# Anowara Fashions Ltd.

35/A ,Hajigonj Road,Narayanganj.

24<sup>th</sup> September 2018

# Observation

Ground Floor Layout

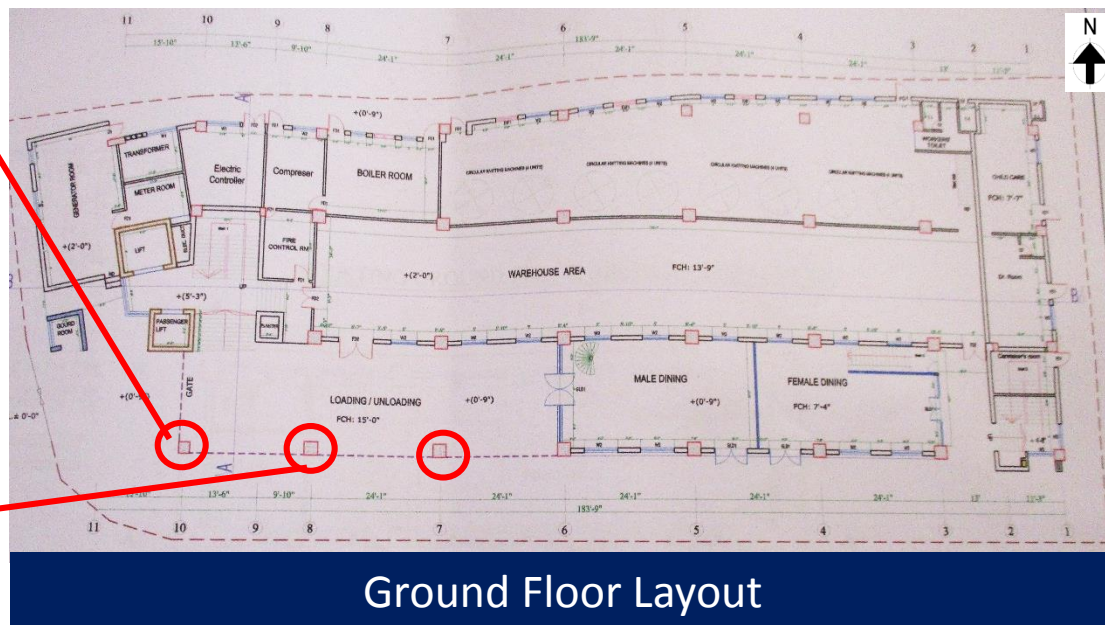
# Columns susceptible to vehicle impact

Impact protection not provided to columns at loading –unloading area. Columns are susceptible to impact loading from vehicles.

| Item No. | Observation                                                  | Recommended Action Plan                                   | Recommended Timeline |
|----------|--------------------------------------------------------------|-----------------------------------------------------------|----------------------|
| 1        | Columns susceptible to vehicle impact. (Factory Building)    | Install a barrier to prevent vehicle impact in column.    | 6-weeks              |
